# UNITED STATES PATENT AND TRADEMARK OFFICE

APPLICATION NO.	FILING DATE	FIRST NAMED INVENTOR	ATTORNEY DOCKET NO.	CONFIRMATION NO.
10/077,072	02/14/2002	Andreas Fischer	P0877	3504

**Office Action Summary**

FIG. 2  
(Prior Art)

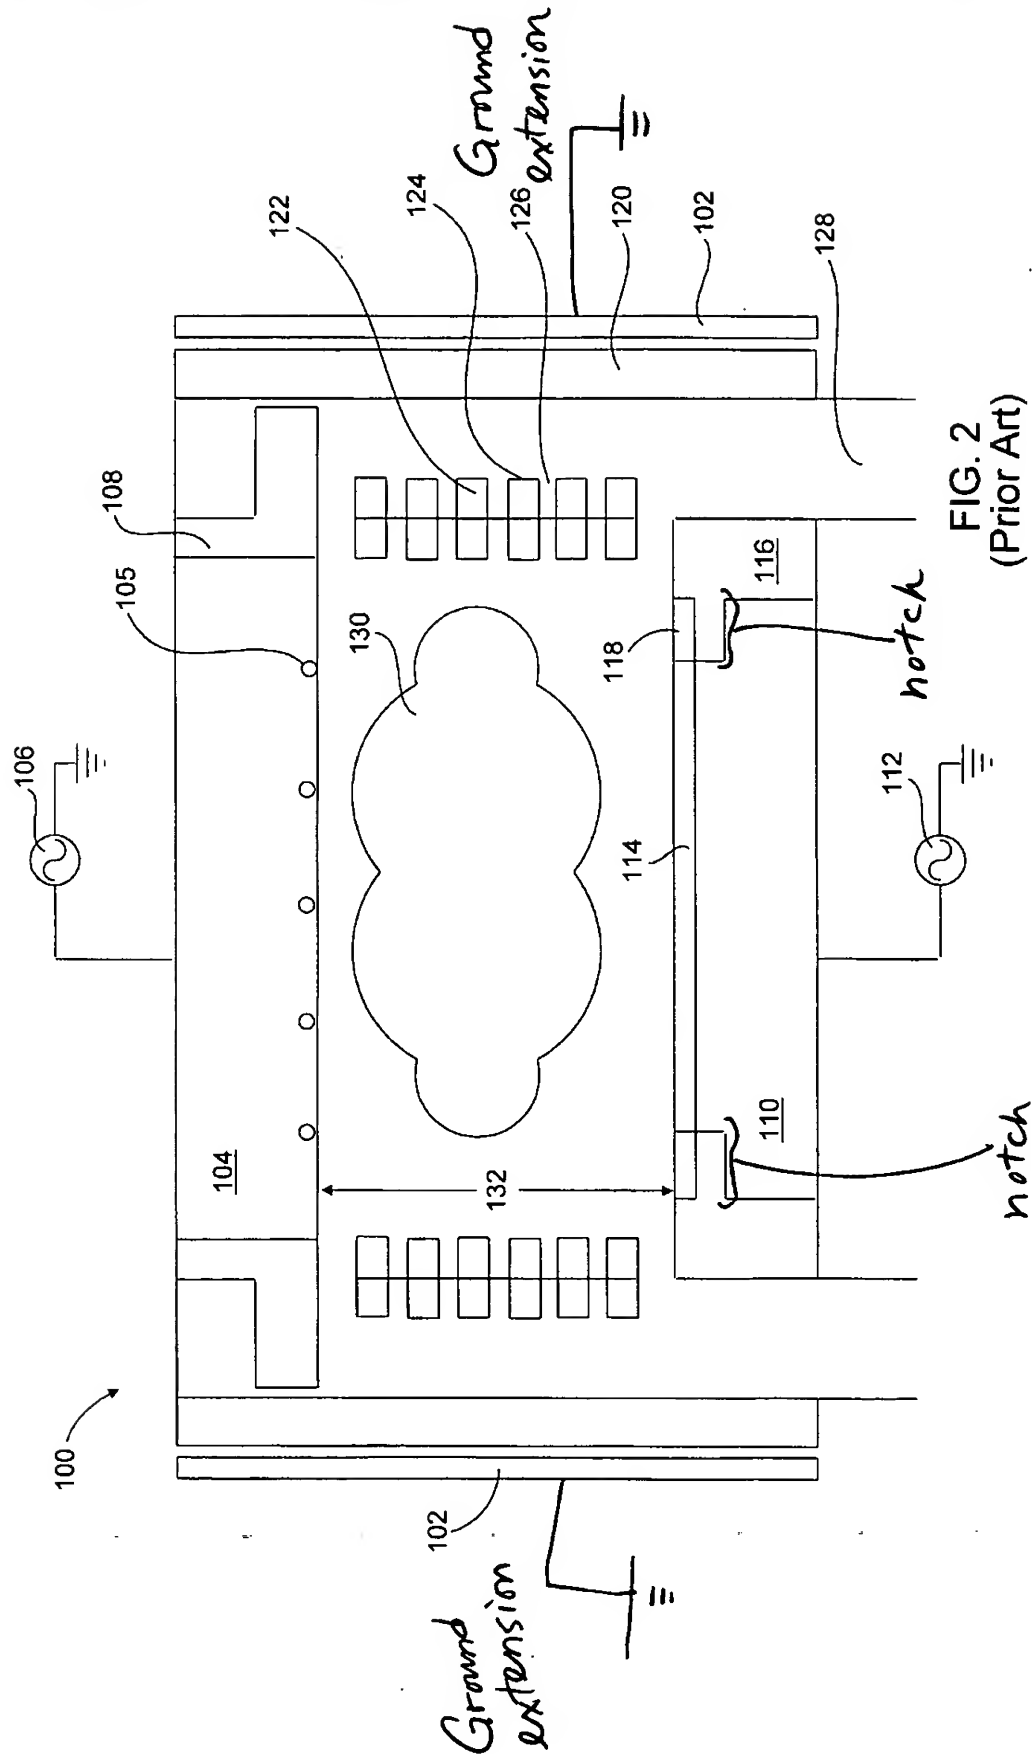
Regarding Claim 1, Li discloses a plasma processing chamber configured to generate a confined plasma (130) (See Figure 2 and Col. 4, lines 30-45), comprising:

- A bottom electrode (110) as a first powered electrode configured to receive a work piece (substrate 114), the first powered electrode (110) having a first electrode area (the top surface of the first electrode 110);
- A RF power source (112) as a power generator operatively coupled to the first powered electrode (110) and configured to communicate power to the first powered electrode (110);
- A top electrode (104) as a second electrode disposed at a distance from the first powered electrode (110), the first powered electrode (110) and the second electrode configured to convert the gas to a plasma (See Col. 2, lines 53-56), the second electrode (104) have a second electrode area (the under part of the second electrode 104);
- A plurality of confinement rings (124) surrounding the confined plasma (See Figure 2); and

- a ground extension (not shown in figure but shown in his teachings) adjacent said first powered electrode (110) and surrounding the first powered electrode (110) since Li teaches that the chamber wall (102) which surrounds the first electrode (110) can be coupled to ground (See attached Figure 2, Col. 2, lines 34-45 and Col. 4, lines 9-12).

Regarding Claim 2, Li discloses a confinement ring (122) configured to confine said plasma, the one confinement ring (122) surrounding said first powered electrode (110) (See Figure 2).

Regarding Claim 6, Li discloses that the ground extension (not shown in figure but shown in his teachings) surrounds said first powered electrode (110) since Li teaches that the chamber wall (102) which surrounds the first electrode (110) can be coupled to ground (See attached Figure 2, Col. 2, lines 34-45 and Col. 4, lines 9-12).

Regarding Claim 7, Li discloses that ground extension (not shown in figure but shown in his teachings) is configured to drain charge (electron) from said plasma since Li teaches that the chamber wall (102) can be coupled to ground (See attached Figure 2, Col. 2, lines 34-45 and Col. 4, lines 9-12).

Regarding Claim 8, since Li discloses that the second electrode area (the under part of the second electrode 104) is greater than the first electrode area (the surface of the first electrode 110) (See Figure 2). Therefore, the electrode area ratio would be greater than 1.0 if the area ratio defined by dividing the second electrode area by the first electrode area.

Regarding Claim 9, Li discloses that the second electrode (110) further comprises a notch (labeled by examiner in attached Figure 2), the notch configured to increase said second electrode area (See attached Figure 2).

Regarding Claim 14, Li discloses that ground extension (not shown in figure but it is taught by Li) is configured to drain charge from said plasma (See attached Figure 2)

Regarding Claim 19, Li discloses draining (e.g. grounding) the plurality of charge (electron) at a plasma boundary defined by at least one confinement ring (122) (See Figure 2 and Col. 2, lines 34-45).
